TECHNICAL BULLETIN

Ref Document No.	TB16001	Issue No.	1
Subject	Crowd cylinder Gland Bush Bolt Failure		
Release Date	8 th March 2016

Purpose – Advise COALTRAM® owners/operators of the possibility of the crowd cylinder gland bush retaining bolts failing.

Applicability – All in service COALTRAM® model CT10 only

Figure 3

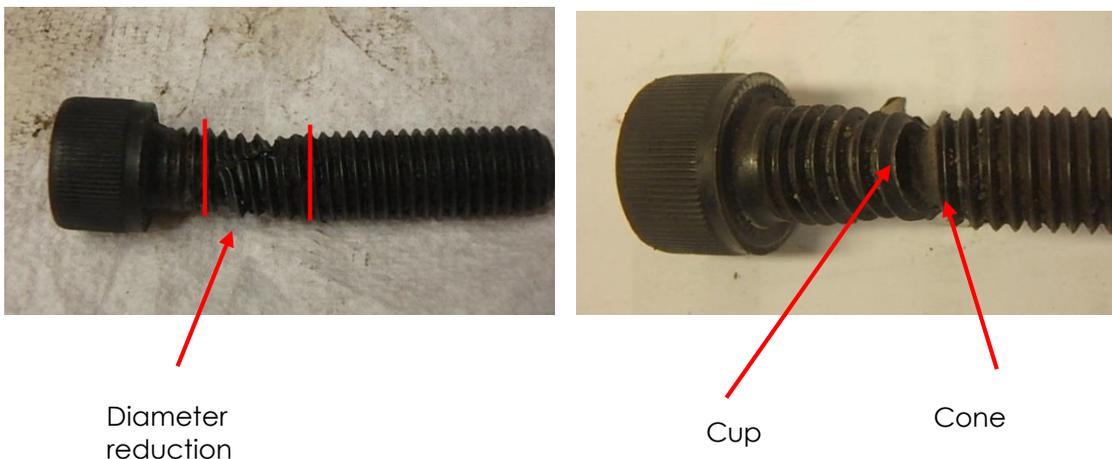
The failure surface of each bolt presented the typical cup and cone failure associated with a tensional load failures. (Figure 3)

Figure 5

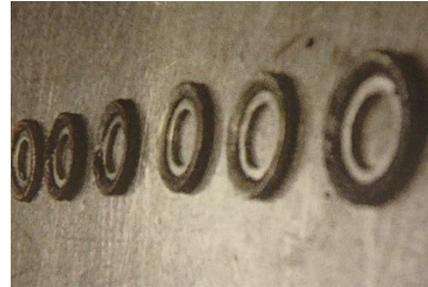
The soft washers were removed and replace them with harden steel Schnorr safety washers (Figure 4). This was done to stop the soft washer from crushing and eventually allowing the bolts to become loose (Figure 5).

2. For the original style crowd cylinder the M12 x 50mm SHCS 12.9 grade are to be torqued to 143 Nm dry. For the new style crowd cylinder the M16 x 50mm SHCS grade 12.9 are to be torqued to 330 Nm dry. This torque is to be checked without the removal of the bolt.

3. If there are any bolts require tightening then all of the bolts and washers should be removed and replaced.
4. PPK can supply a replacement kit for the bolts and washers upon request – old style crowd cylinder P/No. 5520010076, new style crowd cylinder P/No. 55200010081.

5. If new fasteners are installed the additional use of Loctite 263 is to be incorporated into the assembly procedure. M12 cap screws should be torqued to 110 Nm (wet/Loctite applied), M16 cap screws should be torqued to 260 Nm (wet/Loctite applied).
